Service Kit

Title: Bell 429 Air Conditioner Compressor Clutch Re-wire

Applicability: Bell Helicopter Model 429 Equipped with the Air Comm Corporation 429EC-200 and -202 Air Conditioning Systems

This letter explains how to modify the wiring of the compressor clutch on the air conditioning system. The wiring change enhances the grounding to the airframe to increase reliability and system performance. This wiring change also adds a diode for improved noise suppression.

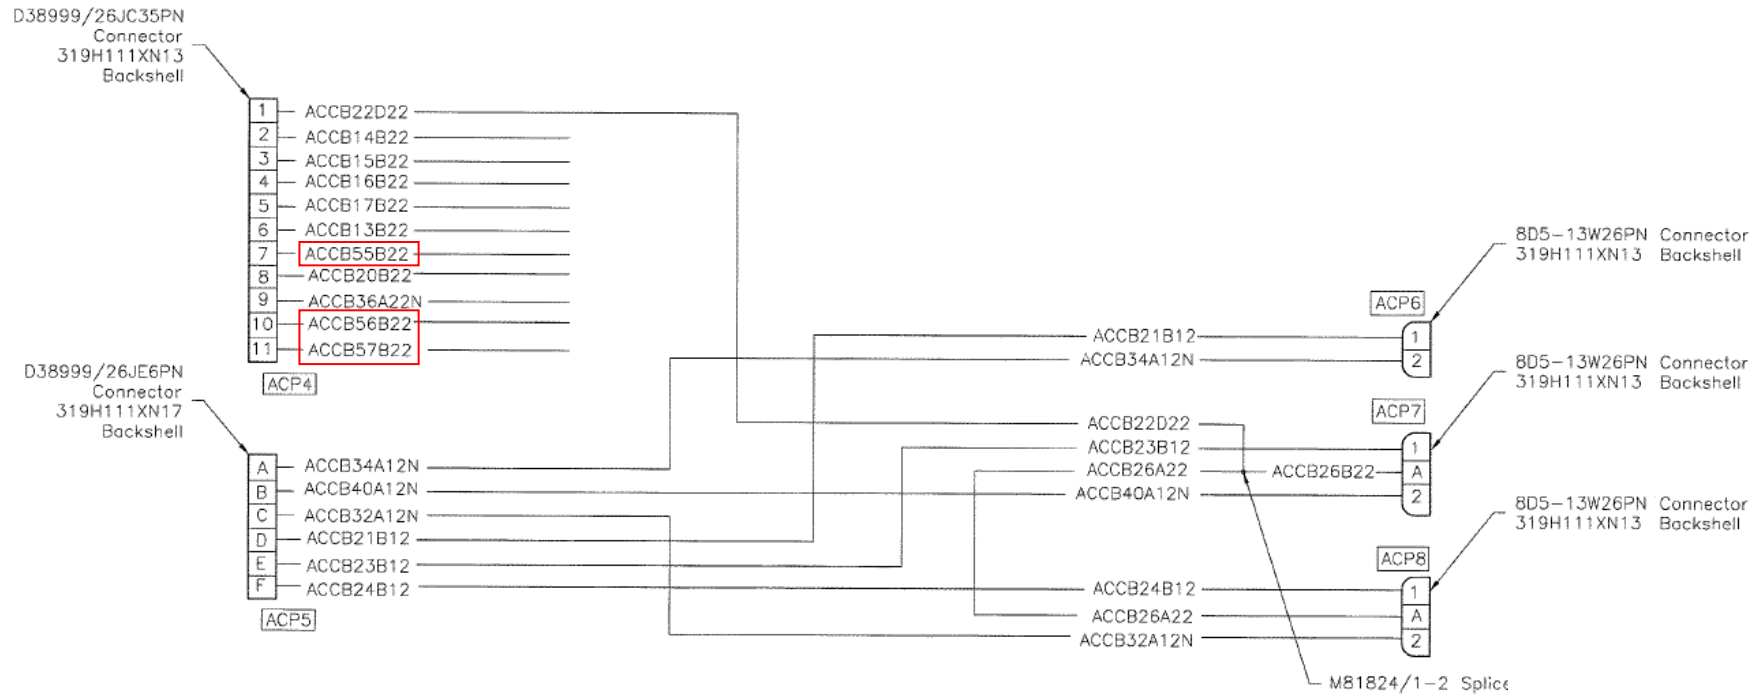
1.2 Modify the -10 harness using the wire in table 1 above.

-12 Assy. Harness (ACP4 & ACP5)

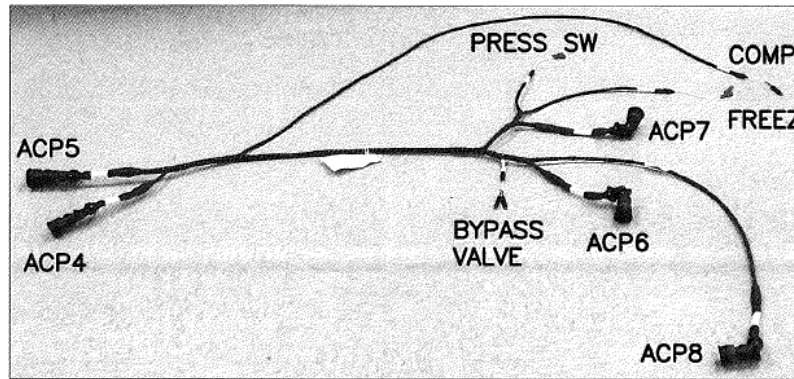
1.3 Modify the -12 harness assembly per table 2 above and the highlighted connections below. The new wires will need to route through the wire braiding between the connector and the strain relief clamps and then tied alongside the existing harness.

NOTE: The schematic above depicts only the connector portion of the -12 harness. The newly added wire ACCB54B22 routed from the clutch splice to the pressure switch terminals is not shown above.

-12 COMP CLUTCH DETAIL

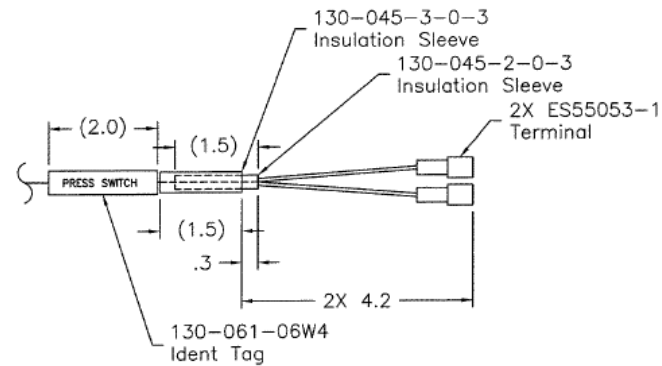
- 1.4 For -12 harness install 1N5408 diode into splices as shown above in "COMP CLUTCH DETAIL" and orient per schematic on last page of this document.
- 1.5 Modify the -14 harness assembly per table 3 above and the highlighted connections below. Leave one end un-terminated until the wires are routed in the aircraft and the final length is determined.
